UNITED STATES PATENT AND TRADEMARK OFFICE

APPLICATION NO.	FILING DATE	FIRST NAMED INVENTOR	ATTORNEY DOCKET NO.	CONFIRMATION NO.
10/698,091	10/31/2003	William J. Worrell JR.	20020391.ORI	9704
23595	7590	06/02/2006	EXAMINER	
NIKOLAI & MERSEREAU, P.A. 900 SECOND AVENUE SOUTH SUITE 820 MINNEAPOLIS, MN 55402			CHAMBERS, TROY	
		ART UNIT	PAPER NUMBER	
			3641

DETAILED ACTION

Fig. 2

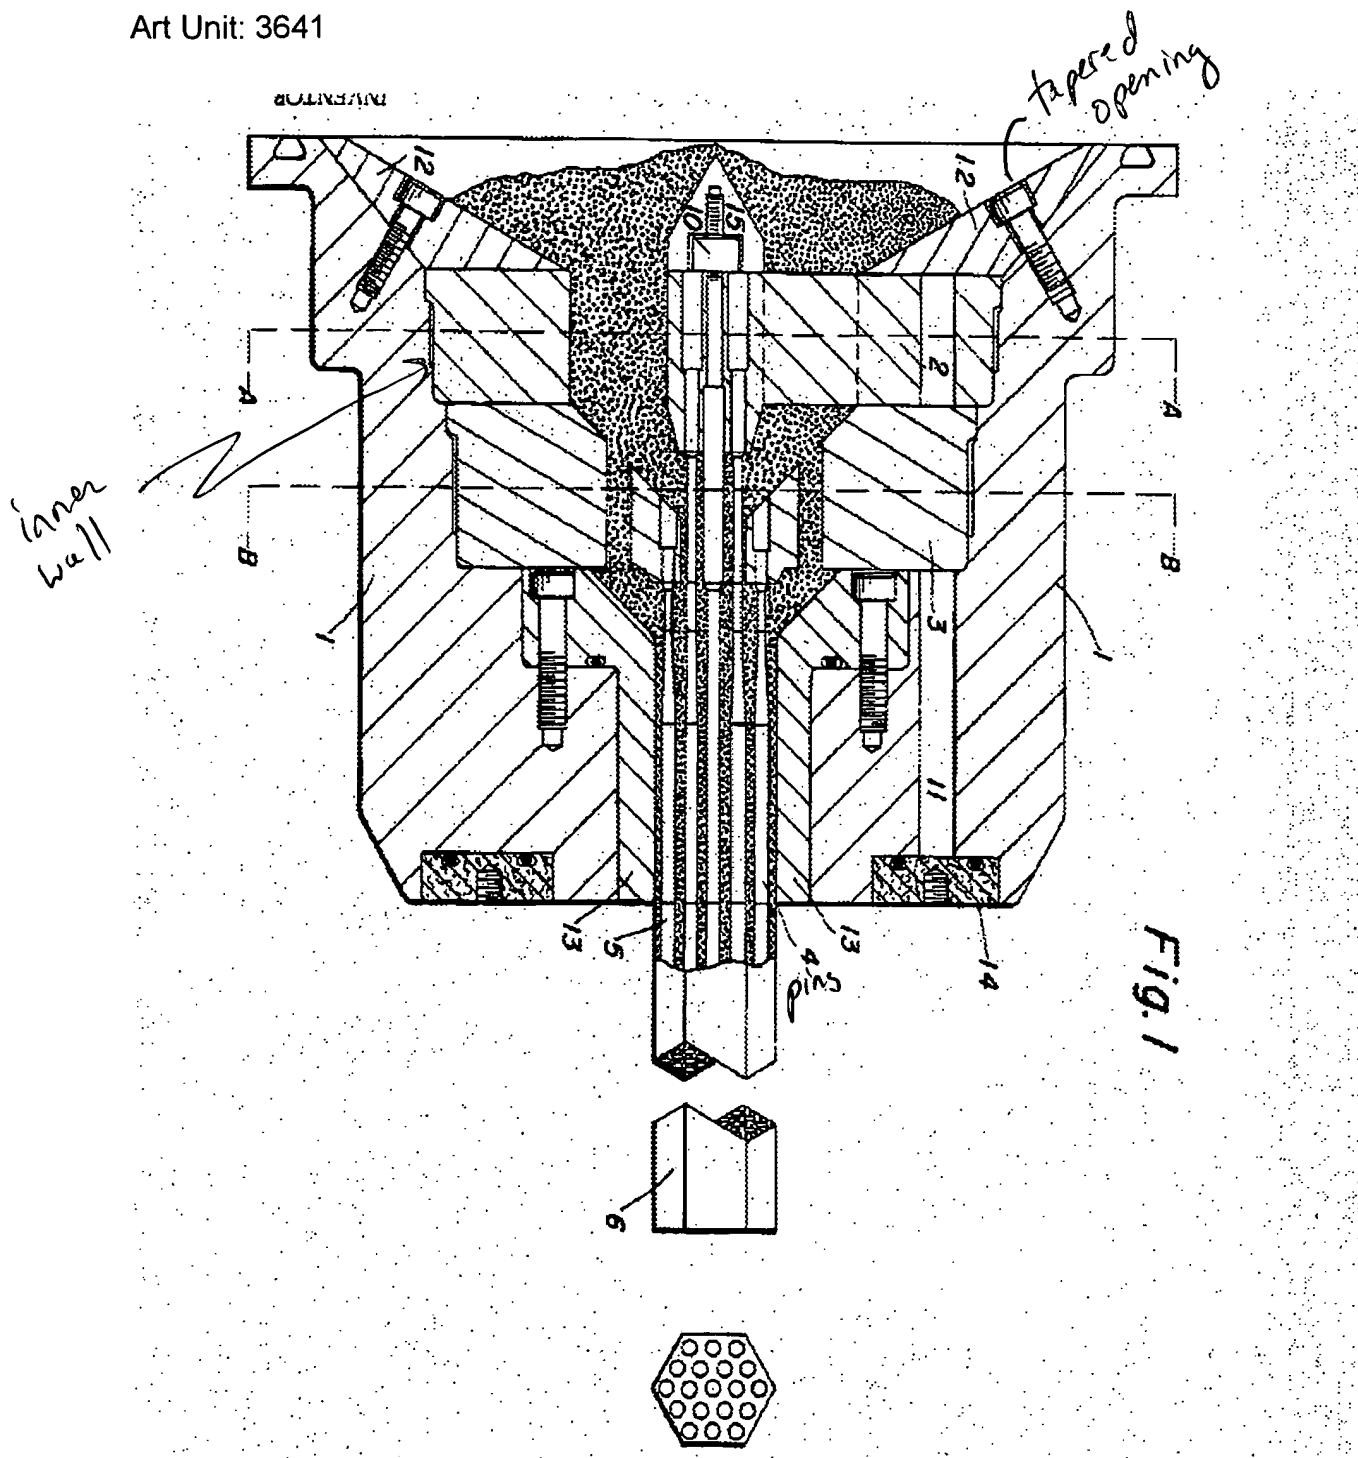
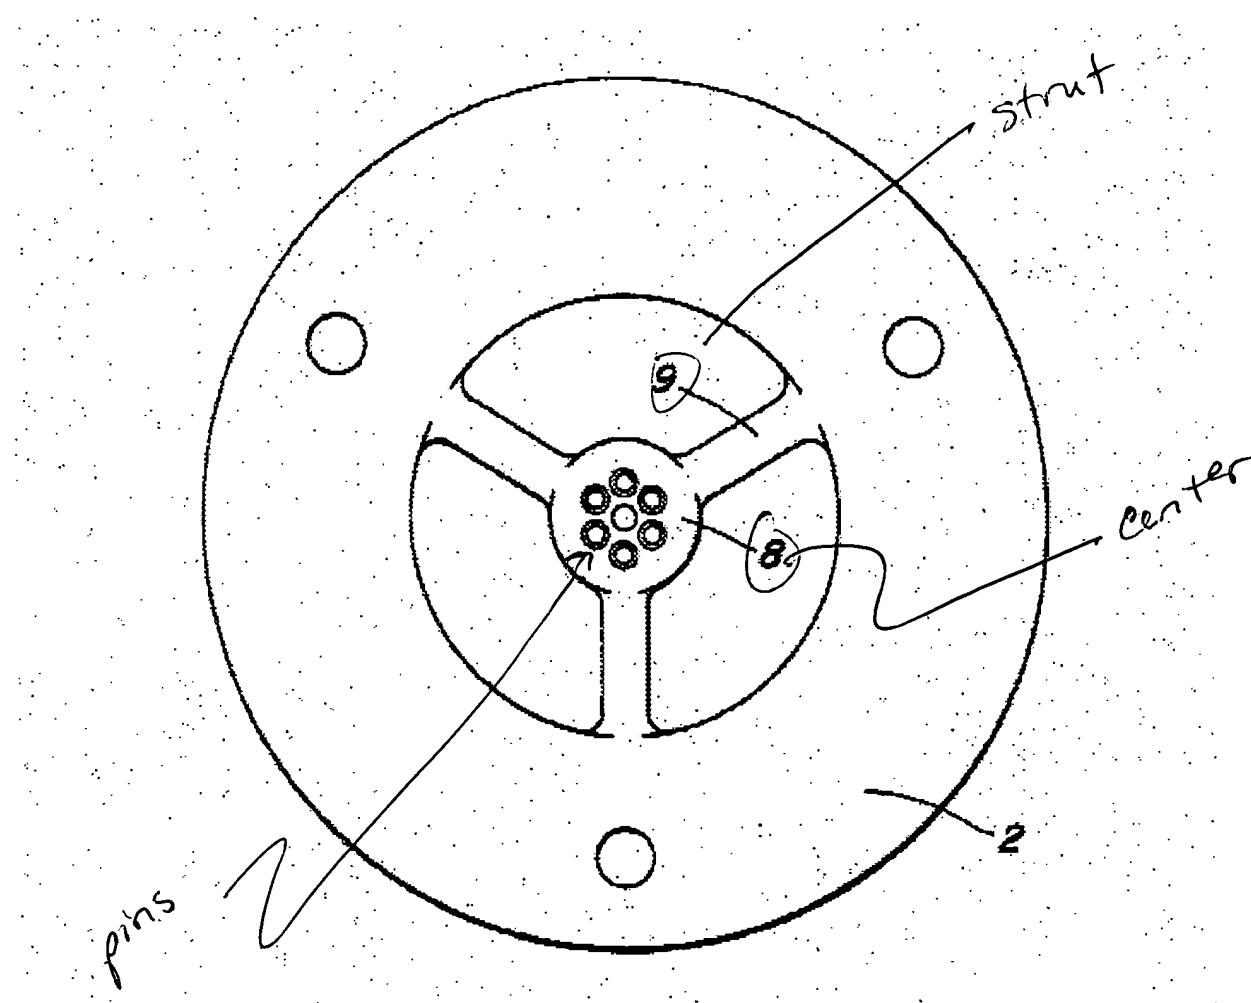
2. Claims 1-7 and 13-15 are rejected under 35 U.S.C. 102(b) as being clearly anticipated by US 3778217 issued to Bustamante et al.

4. Claim 10 is rejected under 35 U.S.C. 103(a) as being unpatentable over Bustamante. Bustamente discloses an extrusion die as shown above. However, Bustamente does not disclose a pin shape that is non-round. At the time of the invention, it would have been obvious to one having ordinary skill in the art to make the pins of Bustamente to be non-round since it has been held that such changes are a matter of design choice. *In re Dailey*, 357 F.2d 669, 149 USPQ 47 (CCPA 1966) (The court held that the configuration of the claimed disposable plastic nursing container was a matter of choice which a person of ordinary skill in the art would have found obvious absent persuasive evidence that the particular configuration of the claimed container was significant.) Moreover, the applicant's specification did not mention that such a shape is critical to the operation of the invention.
